Technical Service Bulletin (TSB)
Key Fob Not Detected When Near Wireless Charger

REFERENCE:	TSB: 08-016-25 REV. C GROUP: 08 - Electrical	Date:	September 11, 2025	REVISION:	08-016-25 REV. B
VEHICLES AFFECTED:	2025 (DT) RAM 1500 Pickup This bulletin applies to vehicles equipped with a Wireless Charging Pad (Sales Code RFX) or Dual Wireless Charging Pad (Sales Code CMS).			MARKET APPLICABILITY: <input checked="" type="checkbox"/> NA <input checked="" type="checkbox"/> MEA <input checked="" type="checkbox"/> SA <input checked="" type="checkbox"/> IAP <input type="checkbox"/> EE <input type="checkbox"/> CH NOTE: This bulletin applies to the North America, South America and Middle East & Africa markets.	
CUSTOMER SYMPTOM:	Customers may comment on one or more of the following: <ul style="list-style-type: none"> • Vehicle may not start. • Key Fob intermittently is not detected when the key fob is placed at or near the wireless charger. 				
CAUSE:	Radio Frequency (RF) interference

Fig. 1
Key Not Detected Message

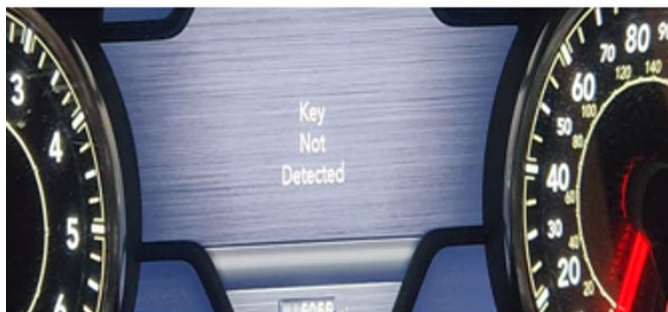
- NOTE:**
- The key fob needs to be at least 203 mm (8 in.) away from the wireless charger and/or do not put a phone on the wireless charger before the ignition is ON.
 - When the ignition is OFF and the key fob near an active wireless charger, interference can occur leading to the key fob not being detected by the vehicle **Fig. 1**.

To verify if the vehicle has this Symptom/Condition, perform the following: Remove any phones from the wireless charger. Verify if the key fob functions/is detected now. **If key fob functions/is detected now, replace wireless charging Pad as required according to the Part Number Supersession table below.**
